Proposed Milton Quarry East Extension
JART COMMENT SUMMARY TABLE – Geology and Water Resources

JART Comments (December, 2022)	Reference	Source of Comment	Applicant Response (January 2023)	JART Response
Report/Date: Geology and Water Resources Assessment Report December 2021		Author: GHD

Groundwater Elevation Contour Plots

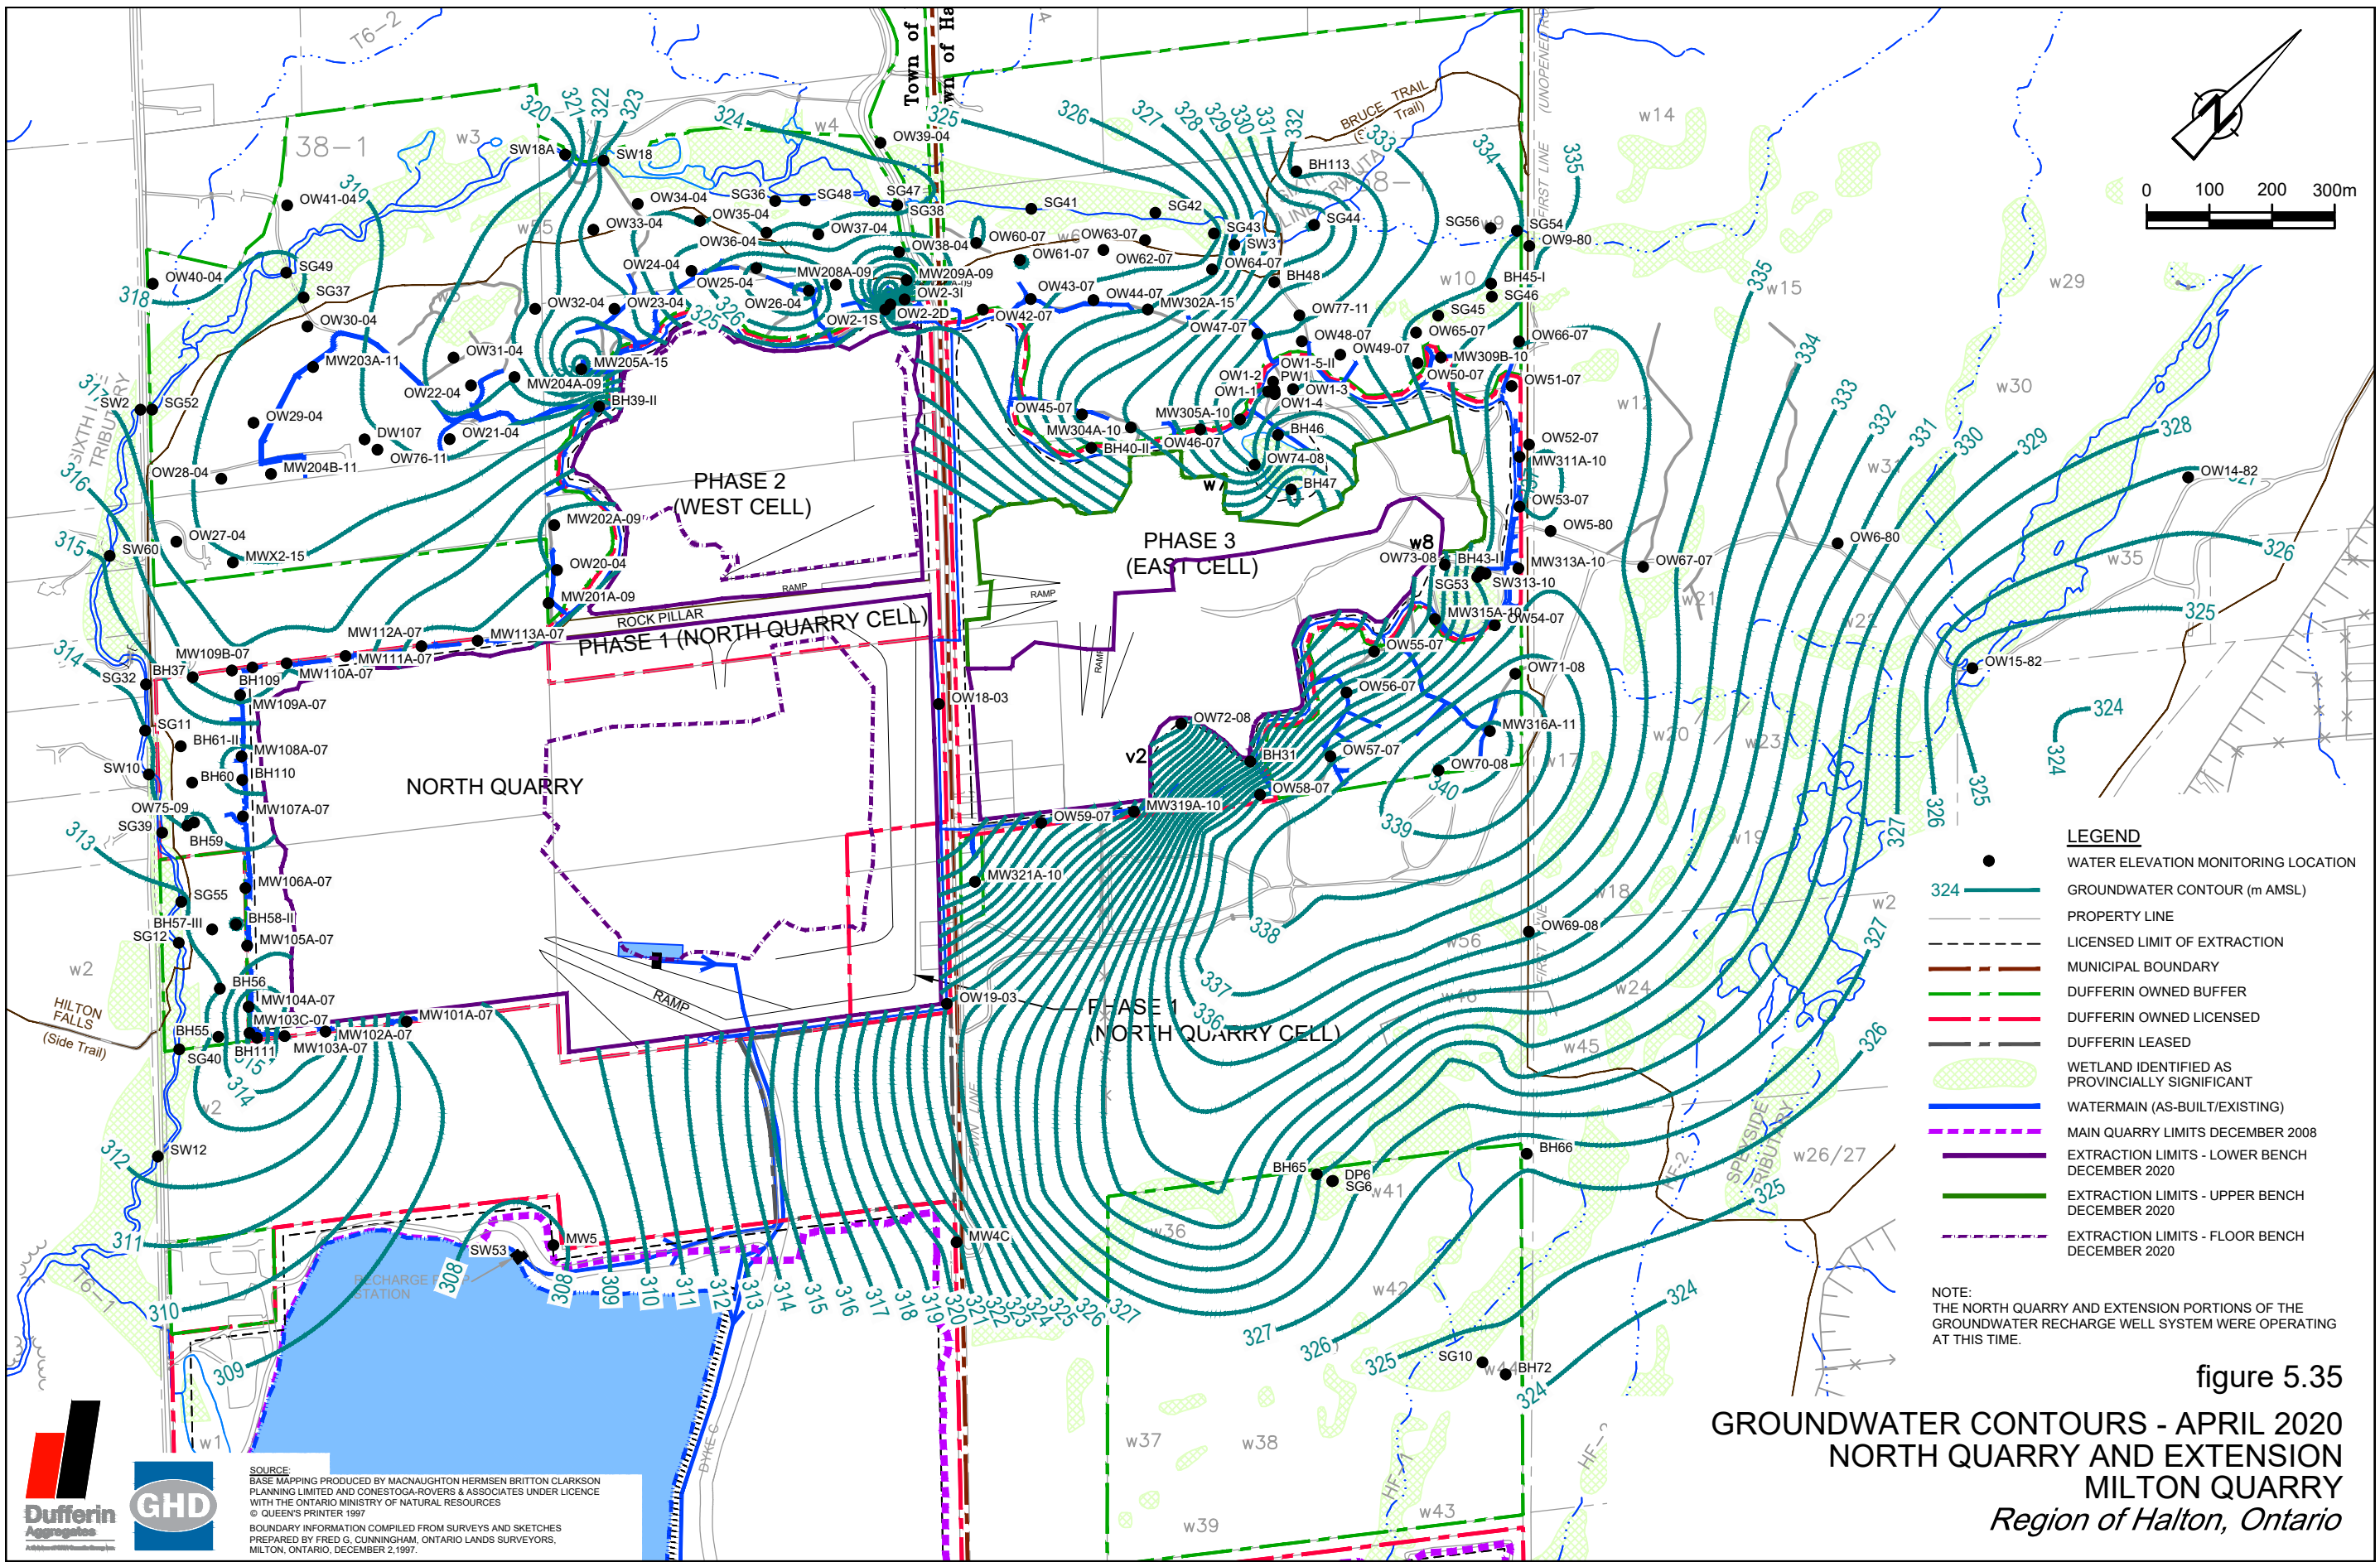
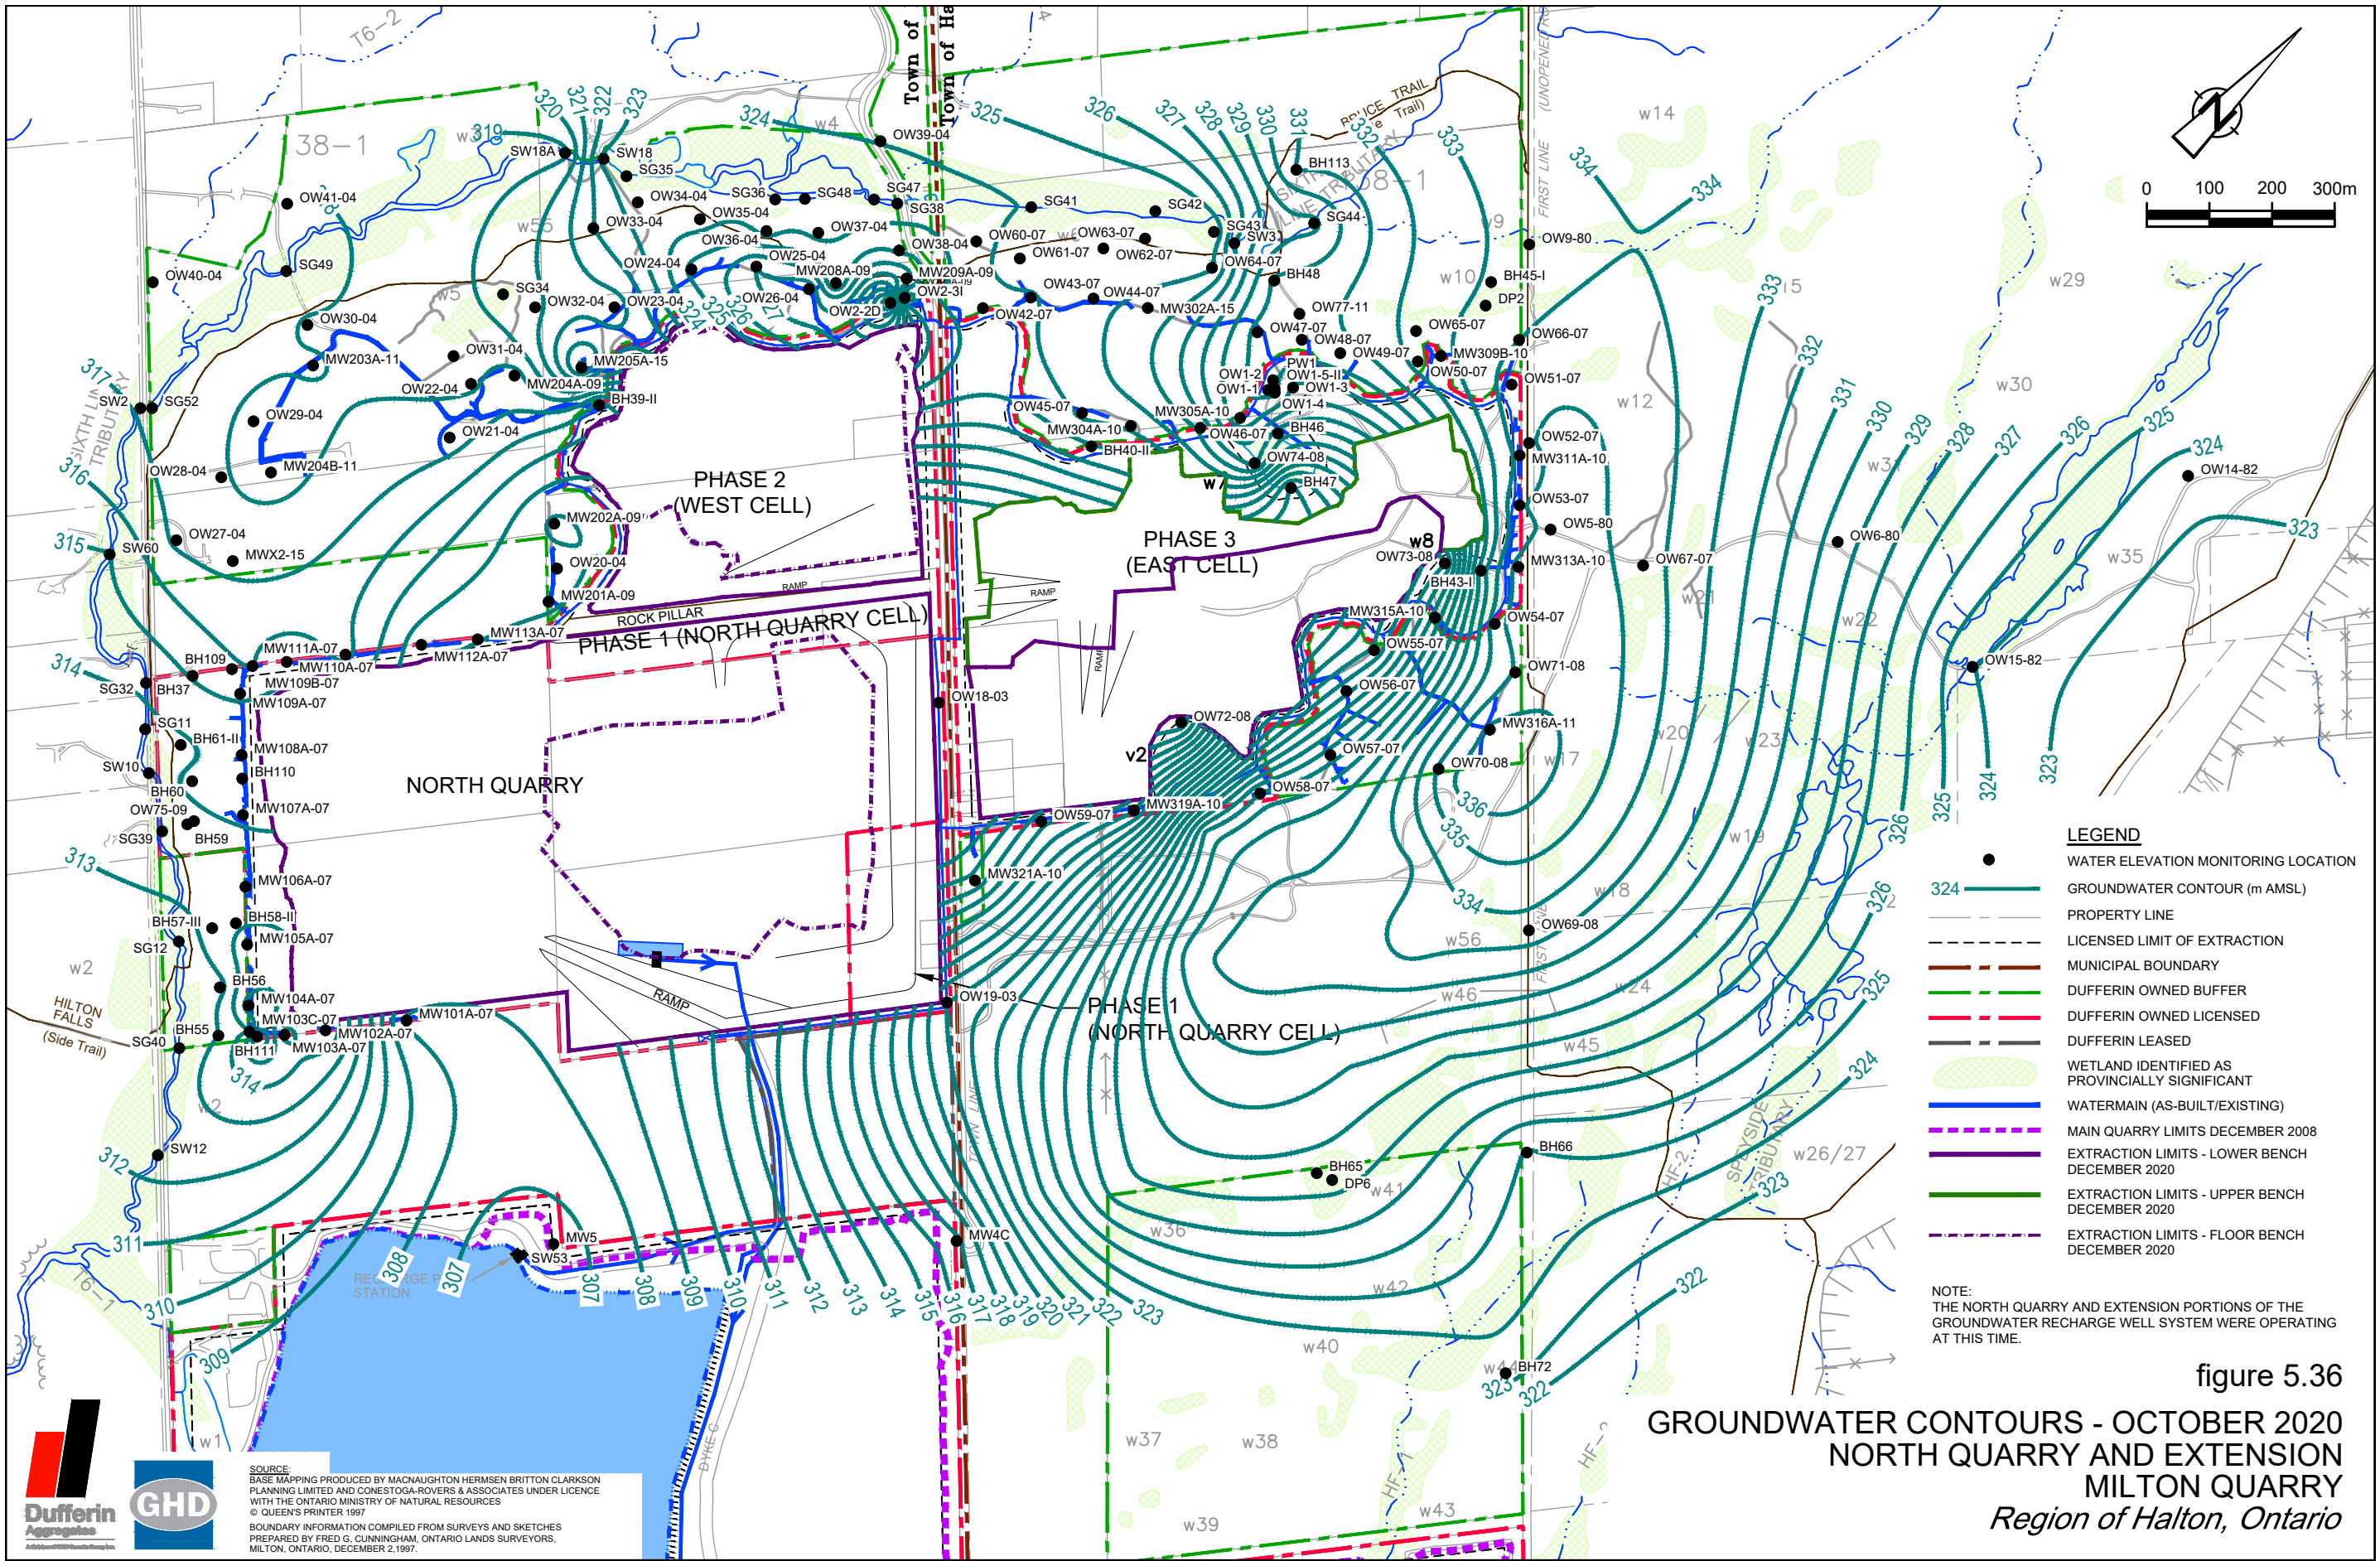
8.	<p>There should be a discussion of the inter-relationship between surface water and groundwater divides and the impact of changing groundwater divides may have on surface water features.</p> <p>Figure 2.8 shows groundwater elevation contours from which regional groundwater flow can be inferred. Interpreted flow directions are not shown on this figure. As noted on Figure 2.8, groundwater elevations <i>'are from MOE drilling records extracted for 2000 GWRA'</i>. An updated version of this figure should be included with recent on-site groundwater elevations to reflect current conditions and the extent of the current zone of influence of the existing quarry. Current groundwater elevation contours are provided for the MQEE area in Figures 6.1, 6.2, 6.3 and 6.4.</p>	Page 11, Section 2.5 Regional Hydrogeology Above Escarpment, 1 st paragraph (Issues list item 1.2)	Norbert M. Woerns	<p>The proposed MQEE will not change groundwater divides. The proposed mitigation measures will support groundwater levels and hence maintain the existing groundwater flow patterns and divides.</p> <p>The groundwater surface water interactions in the MQEE area are described in detail in GWRA Section 6.8.</p> <p>The regional groundwater flow system shown on Figure 2.8 is provided to show the overall regional groundwater flow context. Since the derivation of the dataset, the groundwater flow directions and divides have not been influenced beyond the hydrogeologic boundaries for the Existing Quarry (i.e. the Sixth Line Tributary, North Quarry, Main Quarry, and Niagara Escarpment).</p> <p>Within these hydrogeologic boundaries the groundwater divides have been maintained by the Existing Quarry mitigation measures. Attachment</p>

JART Comments (December, 2022)	Reference	Source of Comment	Applicant Response (January 2023)	JART Response
Report/Date: Geology and Water Resources Assessment Report December 2021			Author: GHD		
				A includes 3 figures from the Annual Monitoring Reports corresponding to the dates of Figures 6.1, 6.2, and 6.3 (i.e., April 2020, October 2020, and April 2021) referenced in the comment. These figures illustrate the overall groundwater flow regime is maintained within the hydrogeologic boundaries of the Existing Quarry. Updating of Figure 2.8 of the GWRA is not warranted and would only change in the local area within the Existing Quarry hydrogeologic boundaries where the remaining areas of Amabel Aquifer are supported by the mitigation measures. The groundwater flow conditions in the local area of interest are better reflected on the MQEE area maps (GWRA figures referenced in the comment) or the Existing Quarry figures from the 2021 Annual Water Monitoring Report (GHD, March 2022) which are included in Attachment A for convenience.
